IN THE MATTER OF | I TE TAKE O Proposed Plan Change 5 (Private):
100 and 110 Te Moana Road,
Waikanae, Kāpiti Coast District

**JOINT STATEMENT OF STORMWATER AND FLOOD HAZARD EXPERT
WITNESSES**

Dated 16th September 2026

Figure 1 Hazard map (Awa Ltd)

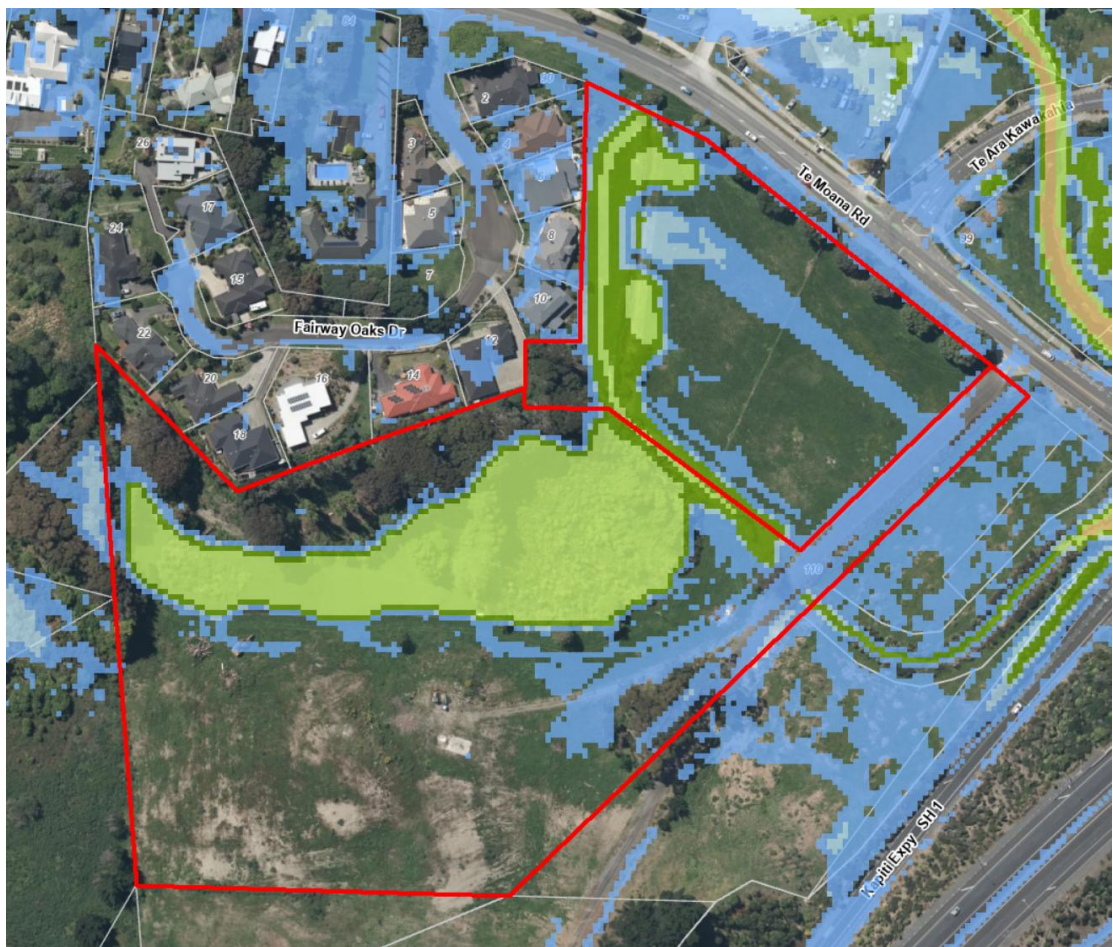
corridor are in the order of 0.1-0.25m, which whilst not complying with the KCDC Subdivision and Development Principals and Requirements Document, is considered sufficient to demonstrate an acceptable solution is possible with further design. A flood hazard analysis of the concept earthwork layout has been undertaken using the vulnerability curves published in the Australian Institute for Disaster Resilience (AIDR) Technical Flood Risk Management Guideline (refer Figure 1 below) and confirms the majority of the road network within the development falls within Hazard classes H1, with a small portion of a road within hazard class H2 (refer Figure 2).
